DRG. TITLE:
VYNOVA RUNCORN

DRAWING No.
607983

Proposed Variation Permit Air emission points

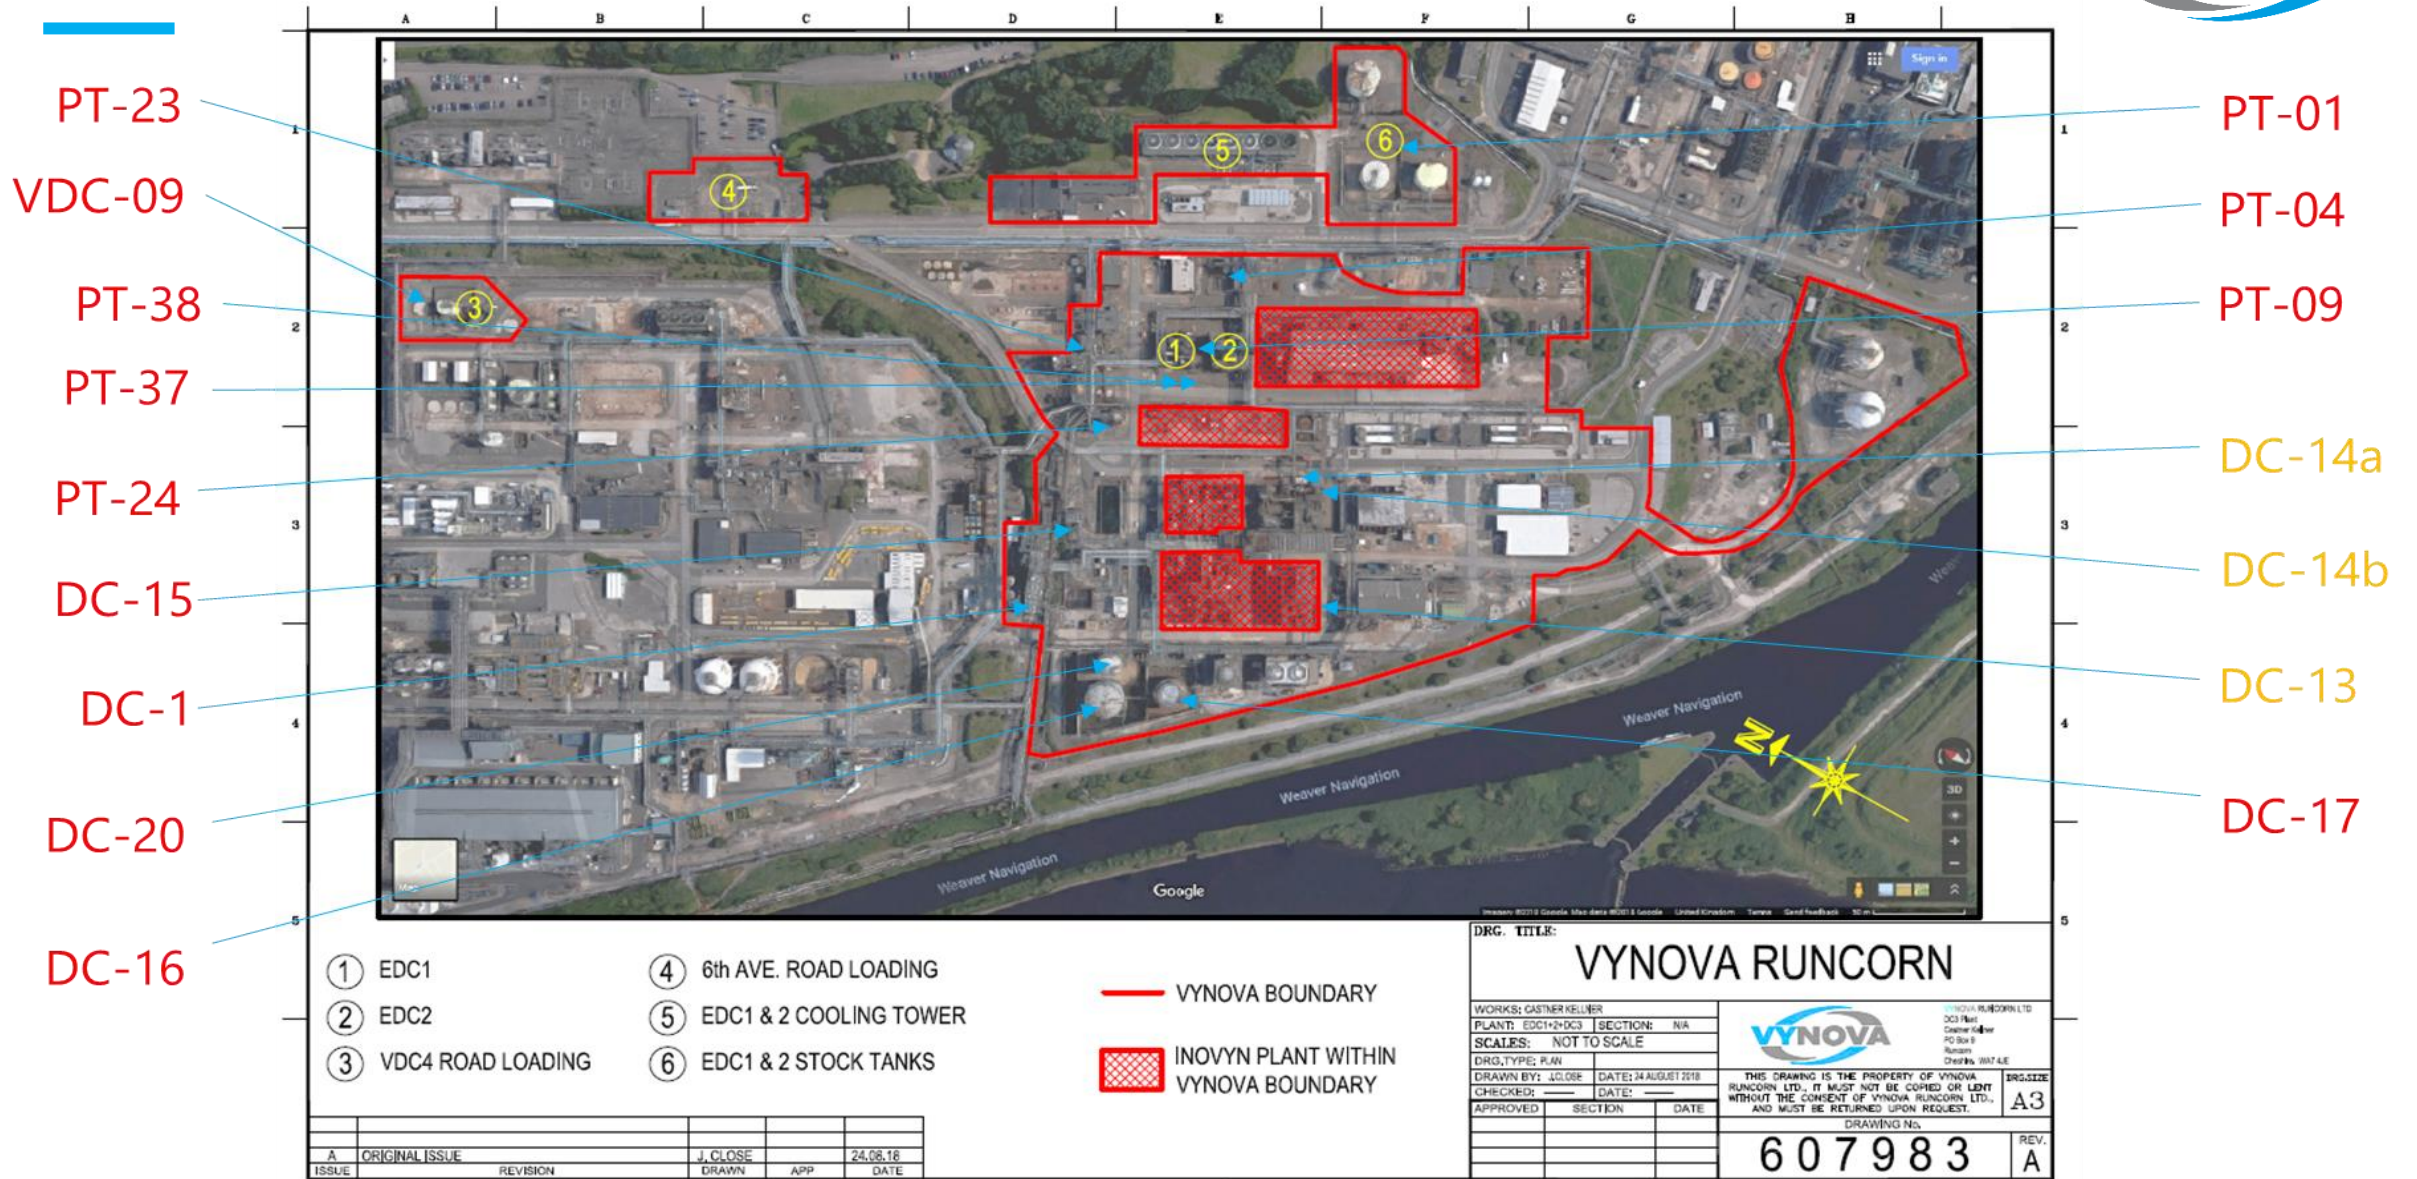
HPE-15
(was DC-15,
but now only non-
reactor dry vent
diversion –
intermittent only)

HPE-1
(was DC-1,
incinerator vent
stack -
continuous)

HPE-21
(new wet vents
scrubber vent –
intermittent only)

HPE-22
(new reactor dry
vents scrubber
vent – intermittent
only)

HPE-23
(new effluent
scrubber vent –
intermittent only)
